# KAMIRA AVENUE VILLAWOOD

DA:303.1/2022/KAMIRA AVENUE VILLAWOOD

RFI - DESIGN REPORT

# **DESIGN EXCELLENCE AND SEPP 65**

**KAMIRA AVENUE  
VILLAWOOD STAGE 02**

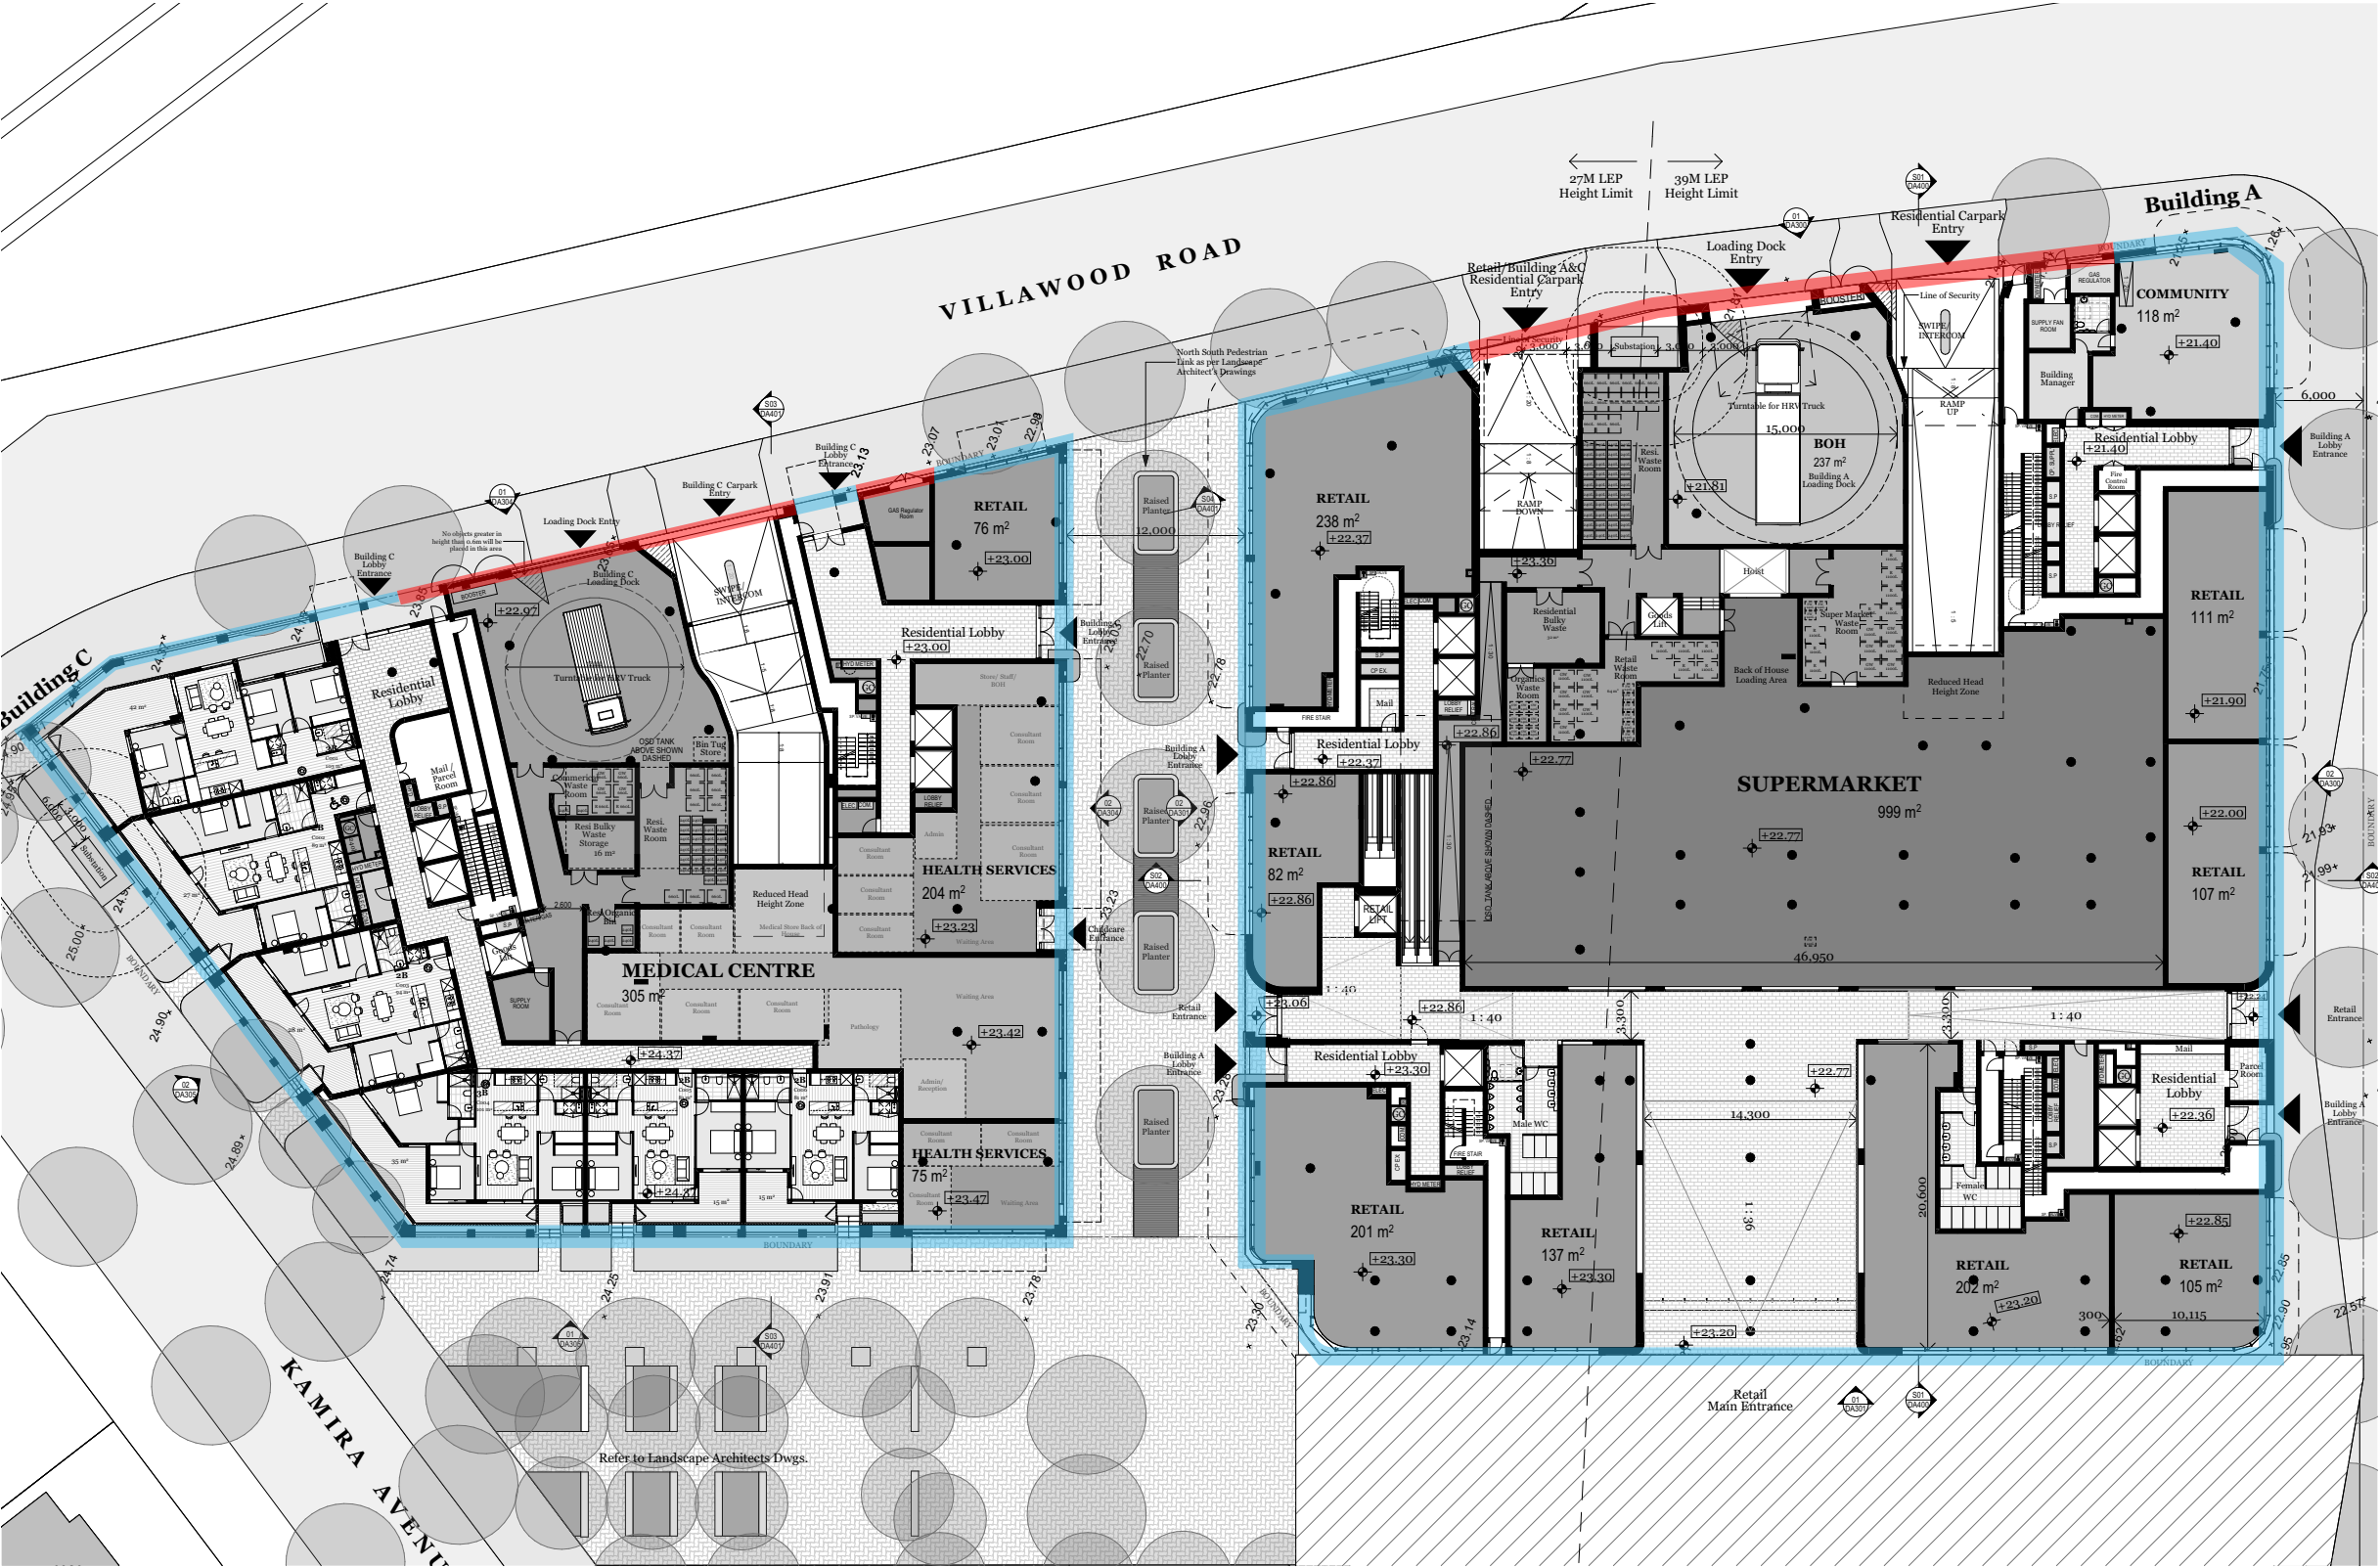
The proposal includes major truck, delivery, car access driveways and services along Villawood Road, which effectively locks this corridor as a secondary pedestrian zone and negatively impacts on the development of an appropriate street/precinct character

The primary pedestrian connection to the site is via Kamira Court and Kamira Ave, facilitating residents' access to Villawood Town Centre. Pedestrian link through the masterplan serve as the main routes for pedestrians to connect to the town center and local transport. Villawood Road functions as a crucial thoroughfare for overall traffic flow to the site. Since the majority of vehicular traffic comes from this road, the loading dock, ramps, and parking facilities for both residential and commercial purposes are strategically positioned along Villawood Road. Furthermore, the proposal minimises the operational back of house areas to 16% facades edges.

0.2

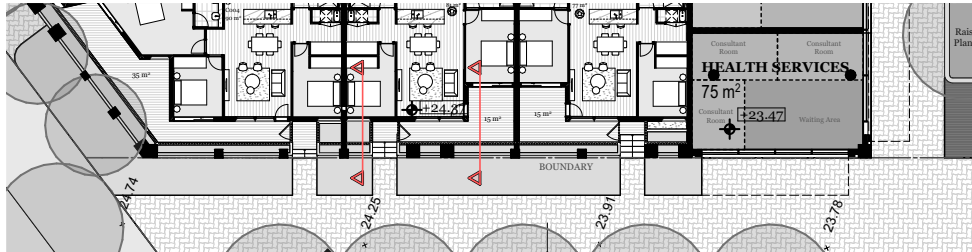
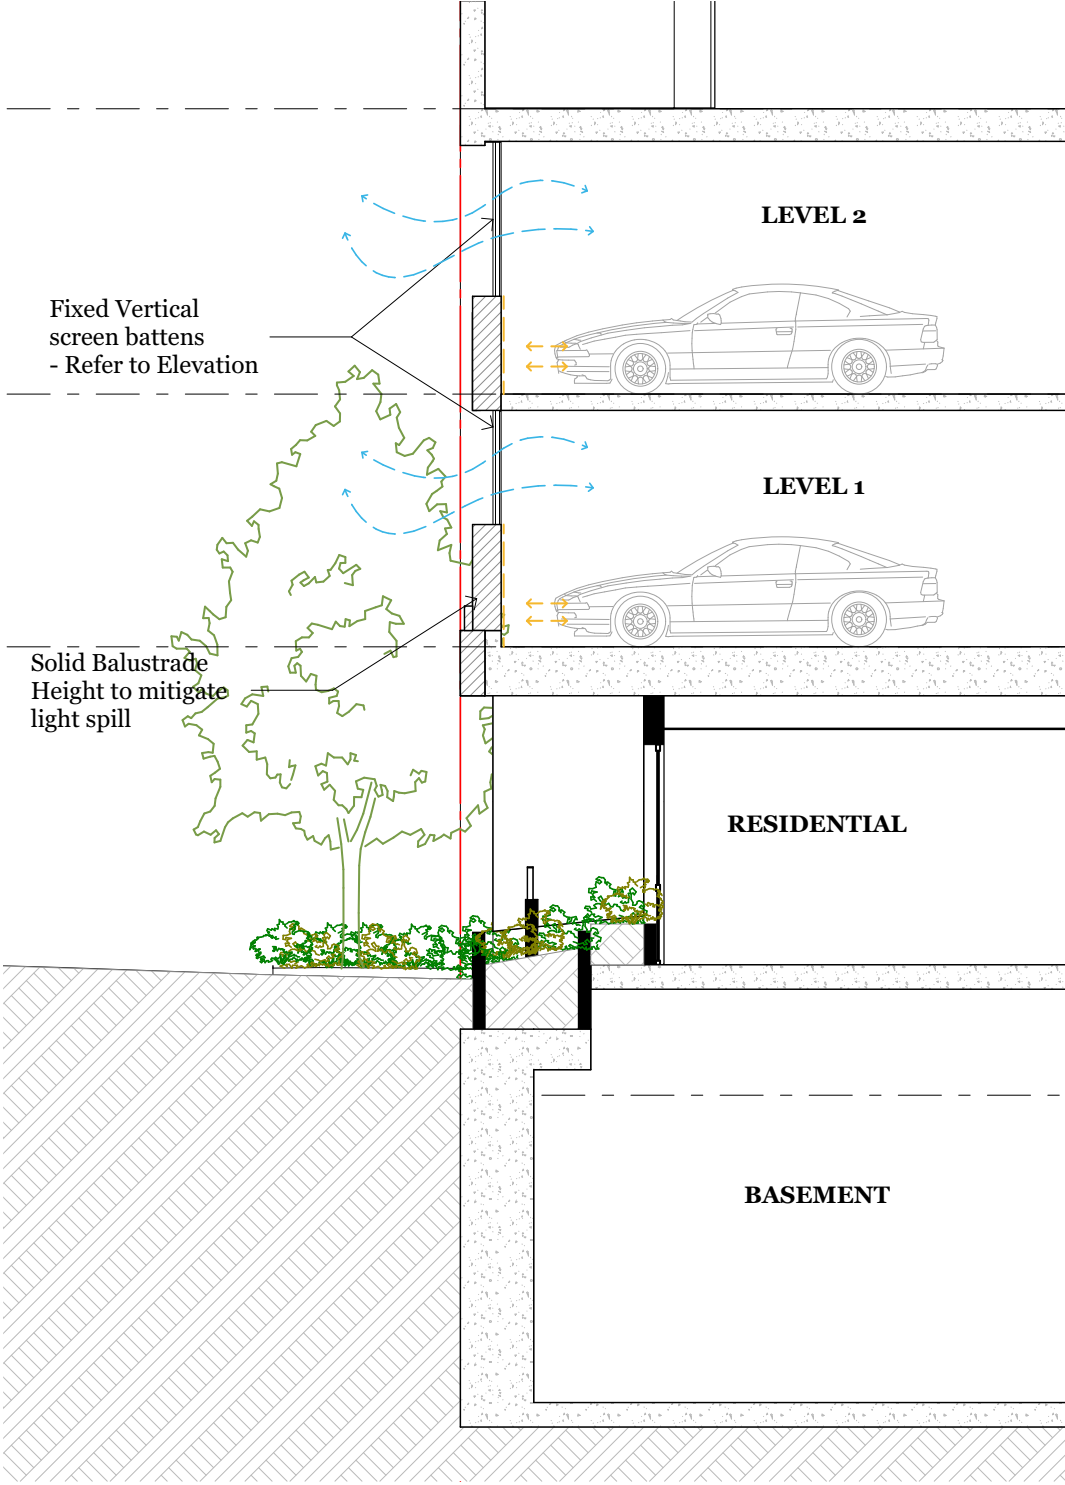
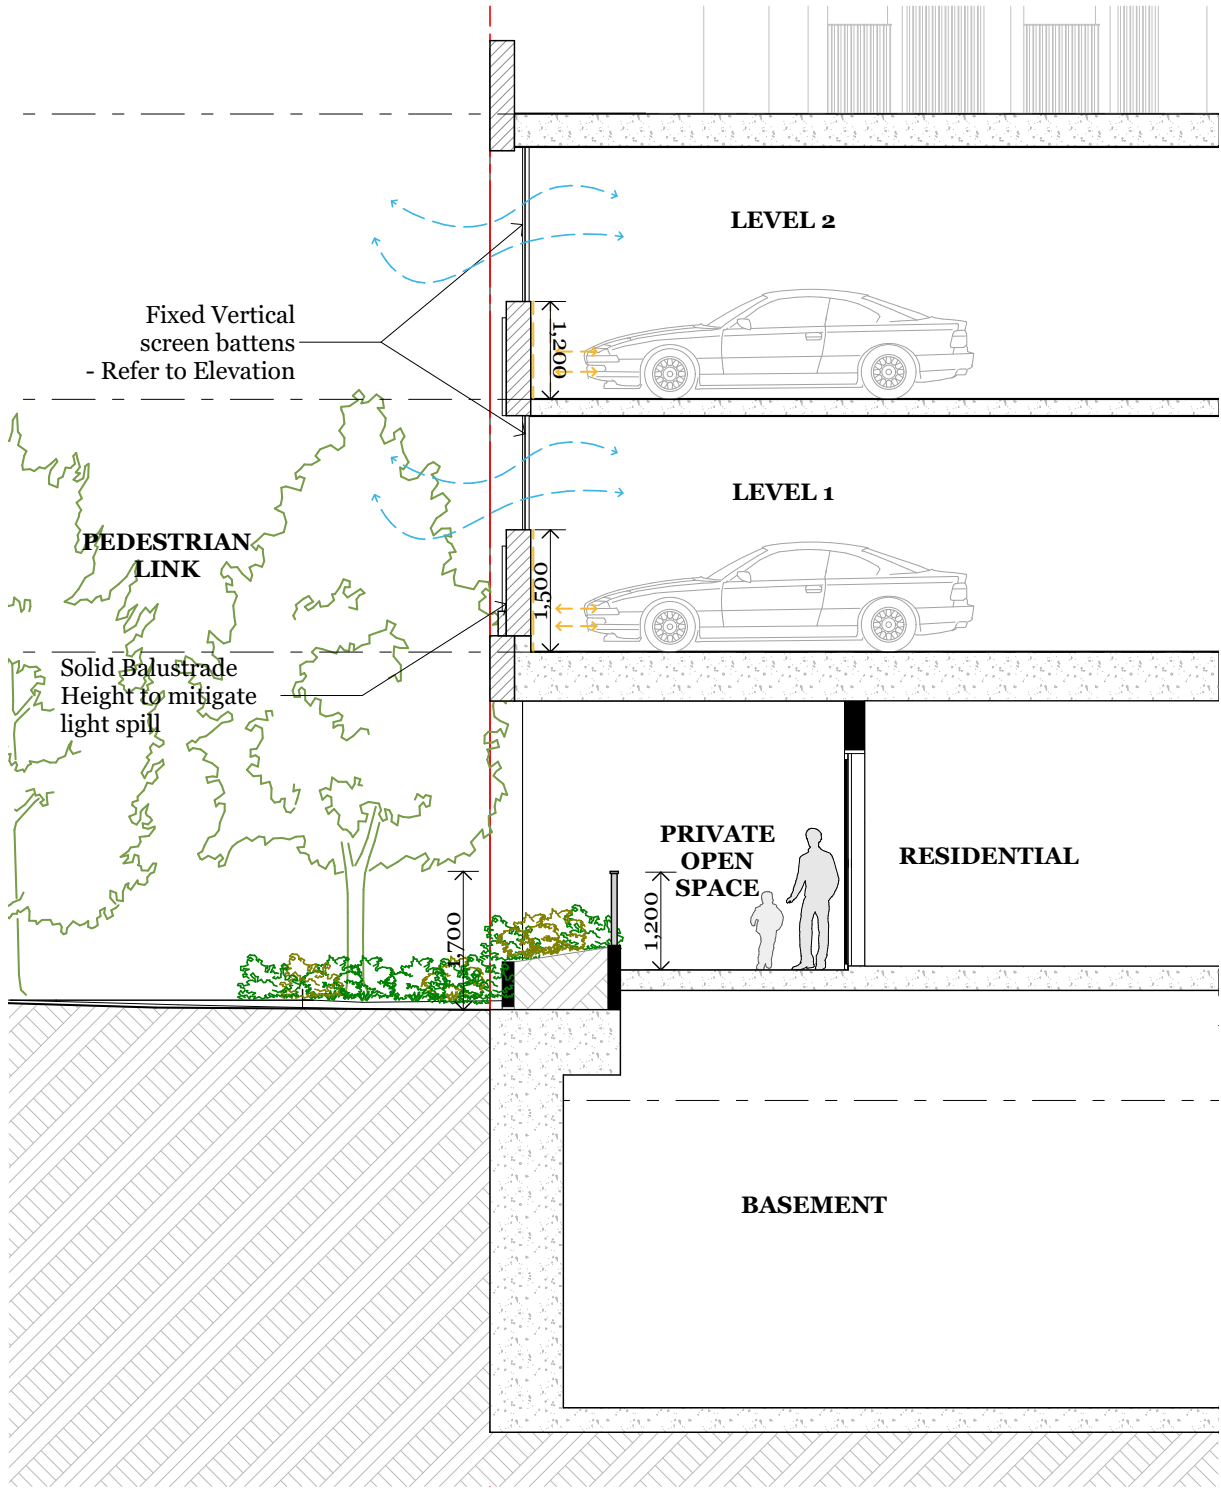
The current design contains substantial above ground carparking within Building C that is not considered to be sleeved appropriately. This sterilises 2 levels of facade facing Kamira Avenue and residential developments to the west, as well as a major edge to the park. This also results in issues of noise, light glare and service /inactive facades to these important new addresses.

There are strong ESD reasons to support above ground parking within podiums as:

- There is a reduction in mechanical ventilation requirements from that of below ground parking; and
- The above ground parking spaces provide opportunity for some time in the future these spaces to be retro fitted for alternative uses such as recreation, storage, etc

Light spill has been mitigated through the solid balustrates within the podium parking levels.
